NON-CONCURRENCE PROCESS

TITLE OF DOCUMENT Confirmatory Action Letter - Oconee Commitments to Address External Flooding Concerns		ADAMS ACCESSION NO. ML103280043
DOCUMENT SPONSOR Meena Khanna / George Wilson (NRR/DE)		SPONSOR PHONE NO. 301-415-2150
NAME OF NON-CONCURRING INDIVIDUAL Jeff Mitman		PHONE NO. 301-415-2843

**STAFF RESPONSE TO NON-CONCURRENCE ON THE INITIAL STARTING RESERVOIR
LEVEL OF THE JOCASSEE DAM FOR THE FLOODING INUNDATION STUDY OF THE
OCONEE NUCLEAR SITE FOR DEMONSTRATING REASONABLE ASSURANCE**

Figure 1: Jocassee Spillway

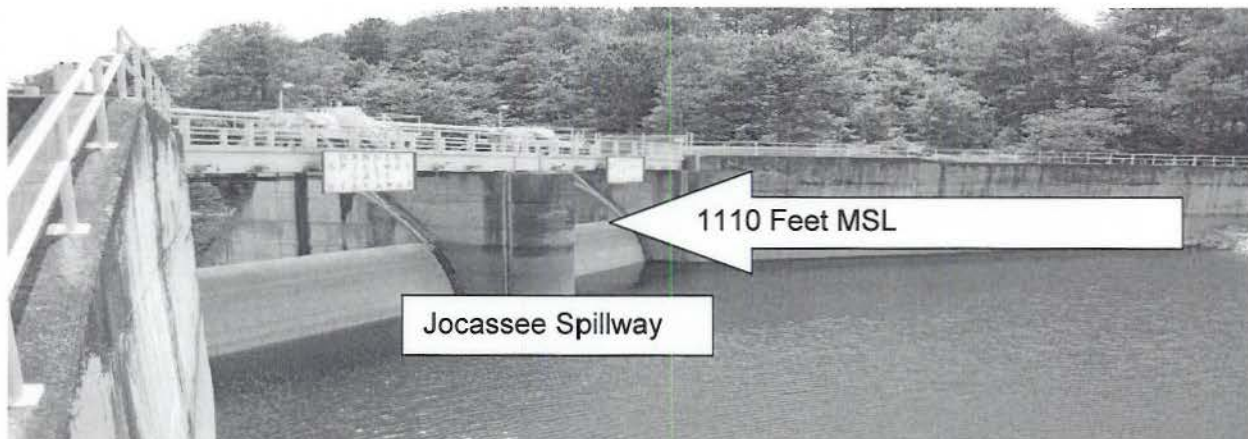
FERC has stipulated the normal operating range of the Jocassee Reservoir as 1080 to 1110 ft msl. The Keowee Reservoir has a normal operating range from 794 to 800 ft msl. FERC also approved the random sunny day failure analysis at a starting reservoir of 1108 ft msl for the Jocassee Reservoir in the 1992 FERC Study performed by Duke Energy. The same rationale applies for the Keowee Reservoir level for being below the top of the operating band. Duke Hydro operates the dams in accordance with the "Keowee - Toxaway Project High-Water Operations Process" procedure. The procedure covers normal and contingency actions for the operation of the dams, specifically the control of the reservoir levels. The contingency actions include lowering the reservoir levels for abnormal rises in lake level and any anticipated significant precipitation. The normal operating pool level of the Jocassee Dam Reservoir is 1108 ft msl, which is 2 ft below the top of the two spillway flood gates, which are at an elevation of 1110 ft msl. Any water level above this elevation would flow over the top of the two spillway flood gates (see figure below). In addition, the maximum allowable operating level during the hurricane season is reduced to 1108 feet msl, to account for any unanticipated sudden heavy

rainfall. This would be the same rationale for the Keowee Dam except it has four gated spillways at 800 ft msl.
